Report to Development Permit Panel

Re: **Application by Vivid Green Architecture Inc. for a Development Permit at
5500 Williams Road**

**Annotated Excerpt from the Draft Minutes from
Advisory Design Panel Meeting**

DP 20-890821 – TWO ARTERIAL ROAD DUPLEXES

PROJECT NO. 1742WPK
DRAWING NO. A101
REV. A

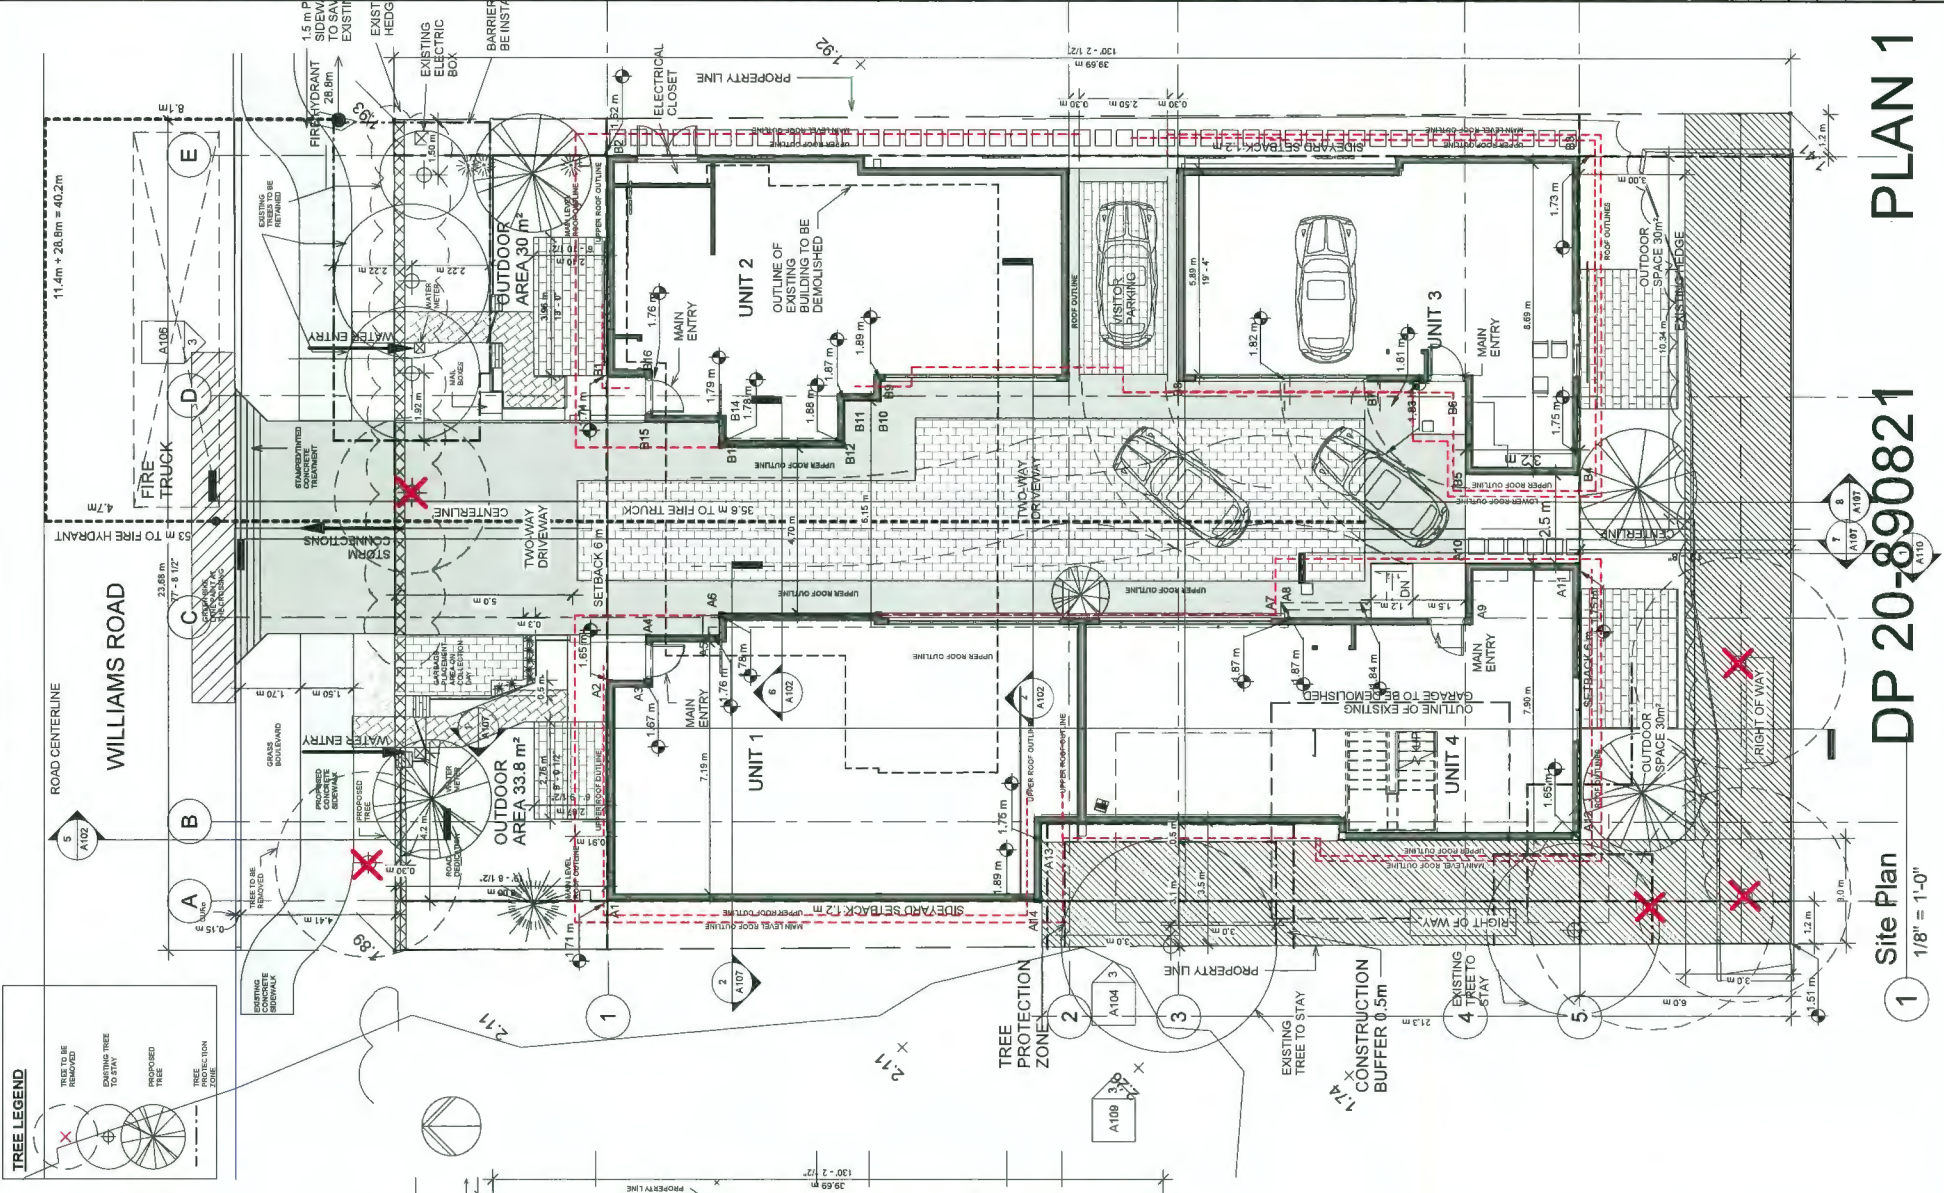
- overall, the proposal is clear; the choice of building and planting materials is appropriate; there are some discrepancies between the architectural site plan (drawingg.A102) and landscape plan (drawing L1) at the entry to the site; the proposed "Garbage Placement Area on Collection Day" is not shown on the landscape plan.

The landscape and architectural plans are edited to match each other.

PROJECT NO.	1742WPK	DRAWING NO.	A105
REV

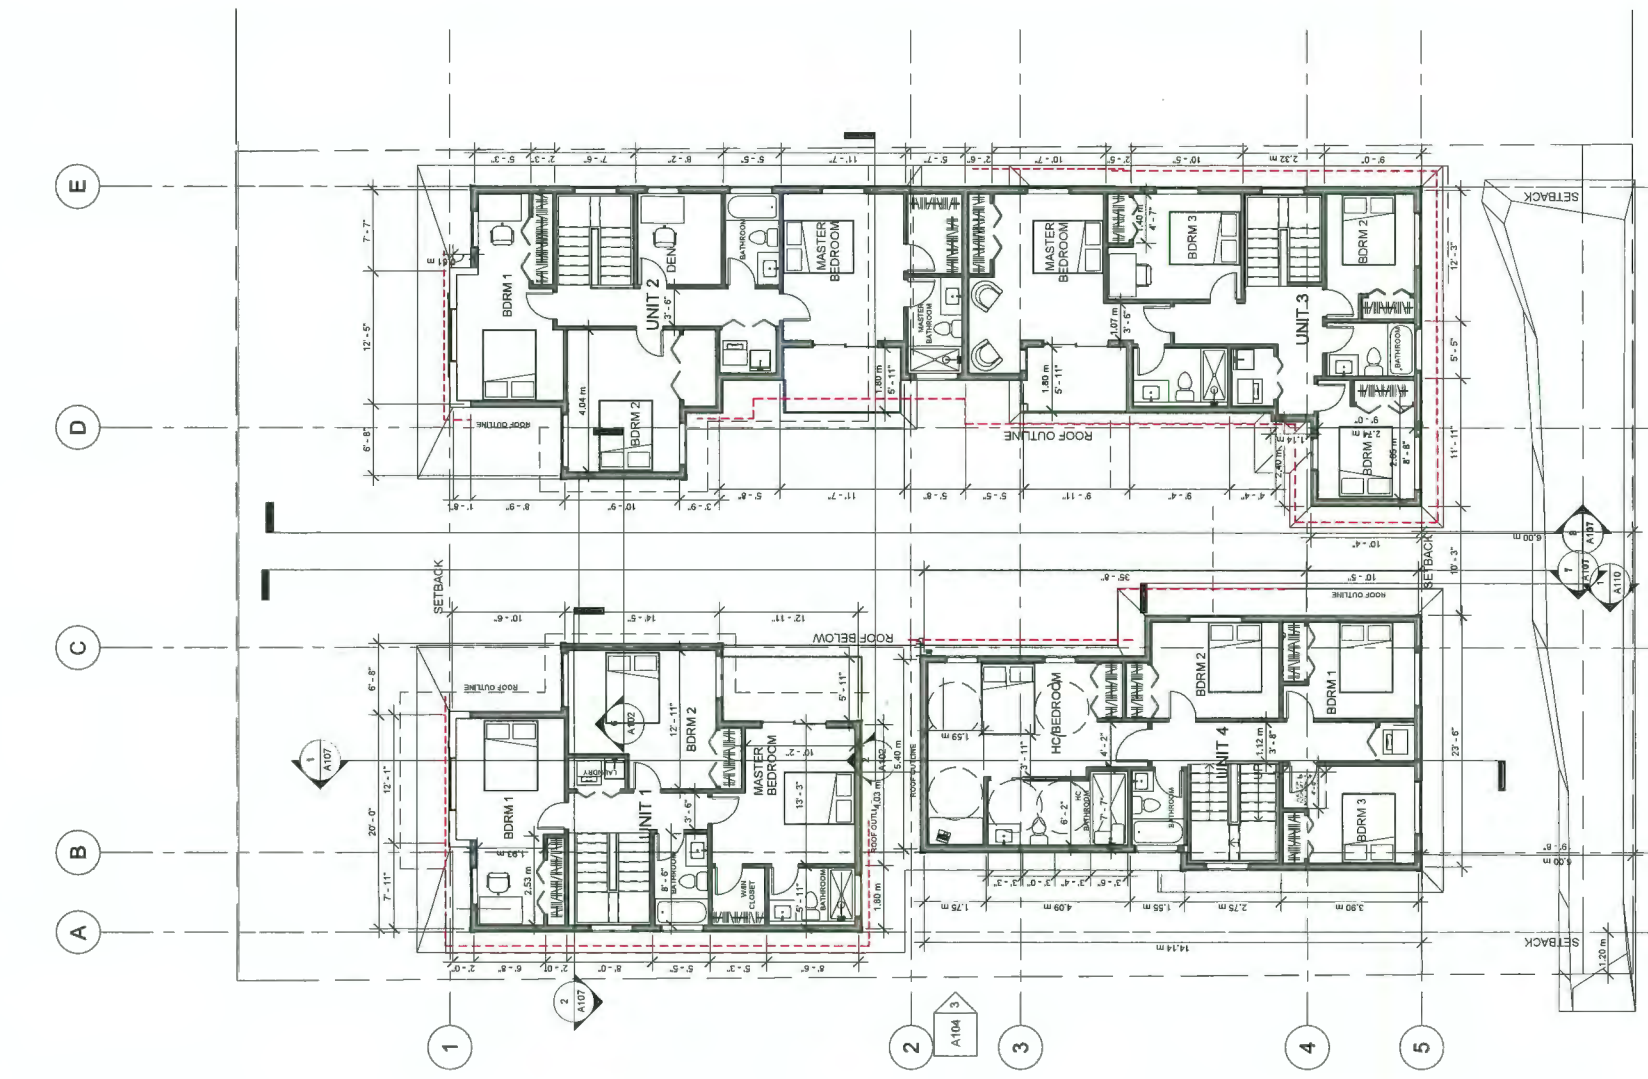
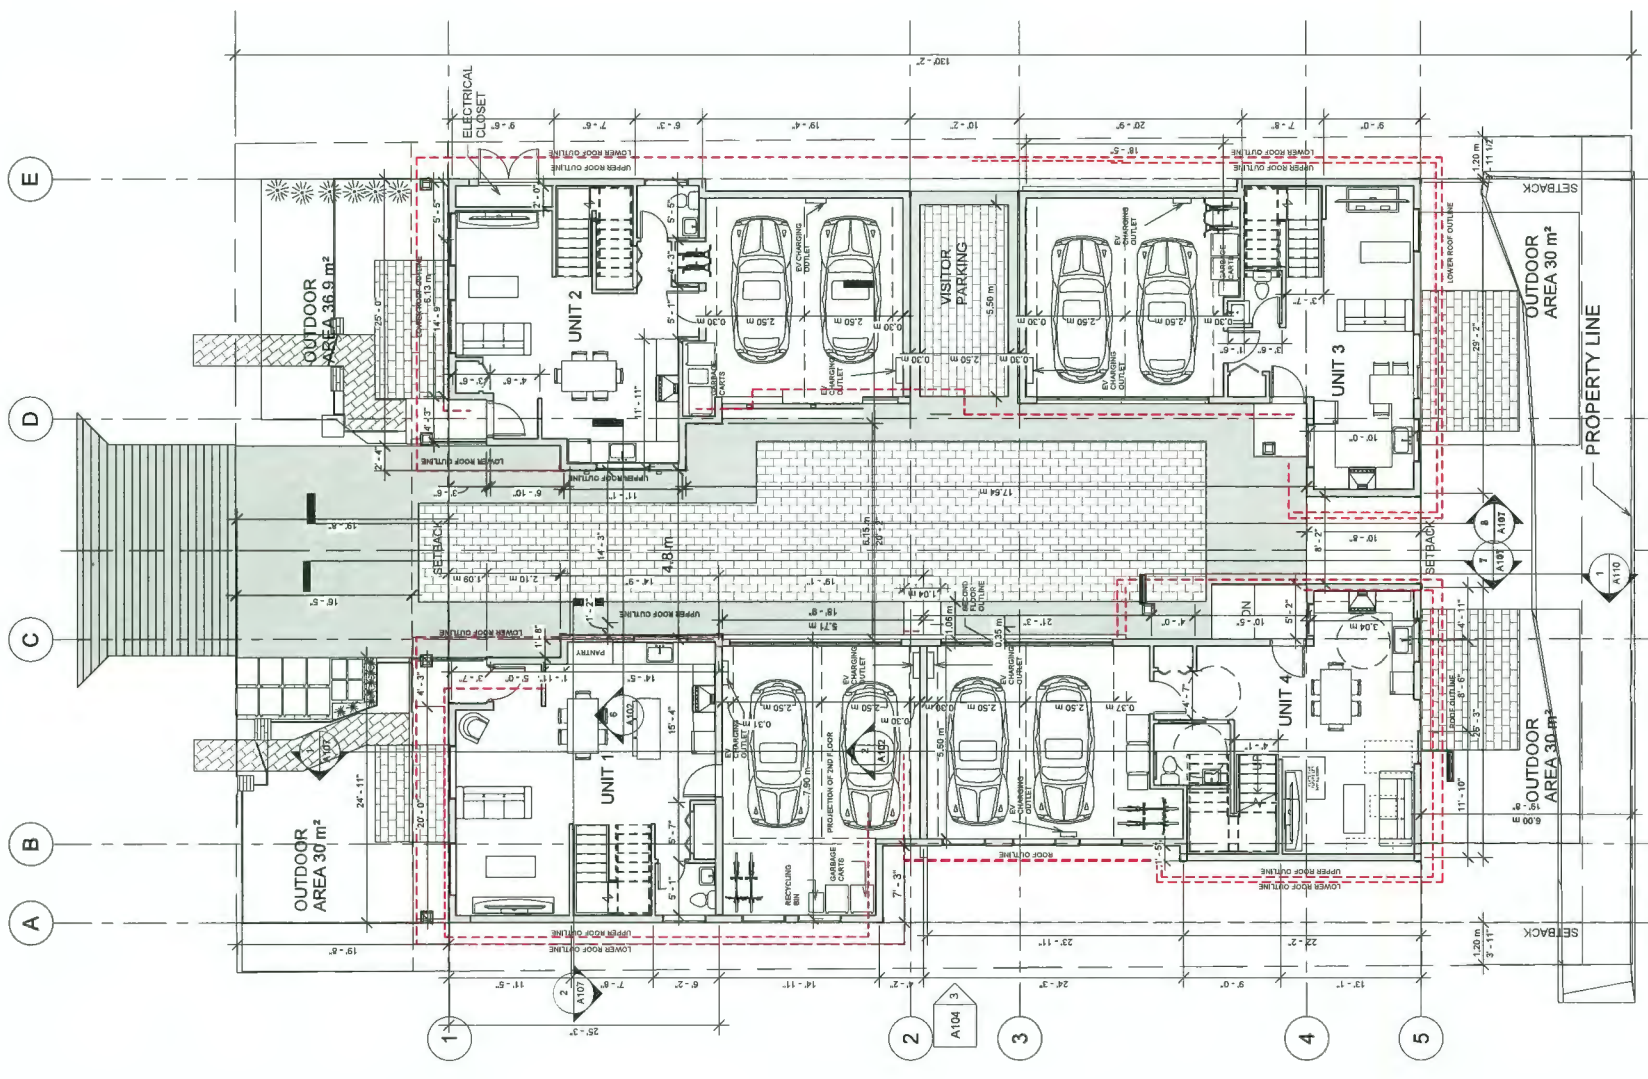
- appreciate the provision of a convertible unit in the project; consider installing pocket doors for all washrooms, closets, and powder room in the convertible unit to make them more accessible for a resident or visitor in a wheelchair;

- a chair lift does not provide safety and independence for people using walkers and those in a wheelchair; consider providing adequate space for future installation of a vertical lift;

Pocket doors proposed for HC accessible washrooms. Please refer to page A105, unit 4.

Place for the future lift installation is proposed beside the stairs (page A105, unit 4).
